Our Ref: 2676-21

Kirstyn Royce Planning Consultant Central Otago District Council

RESPONSE TO FURTHER INFORMATION REQUEST – RC 230398: 88 TERRACE STREET BANNOCKBURN

Figure 1. A former subdivision option which included a 5.39ha area of land for vesting as reserve (Lot 200).

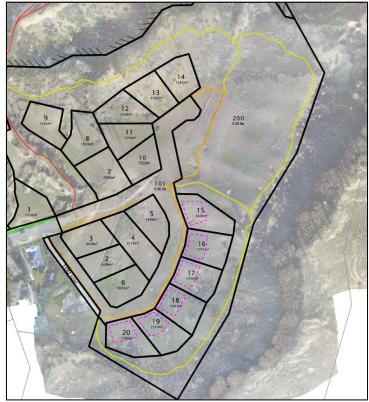
5. Please provide details of the discussion held with Council officers in 2022 and early 2023 regarding future management of Lots 30 and 40 [and 51].

Attached is communication between Mr Chris Fowler for the Applicants, and the Council's Parks Officer Mr Gordon Bailey dated 14 June 2023. The communication refers to the Applicant's request in December 2022 for a 5.39ha area of land which included walkways to be vested as reserve shown as Lot 200 in Figure 1 below, with this offer not supported by Mr Bailey.

Subsequently the Applicant proposed a much reduced recreation reserve / lookout within Lot 30 of the present proposal.

The latter part of the attached communication contains an email dated 24 August 2023 where Mr Bailey confirmed support for the reduced reserve area which is shown in the proposed plan of subdivision at Lot 30.
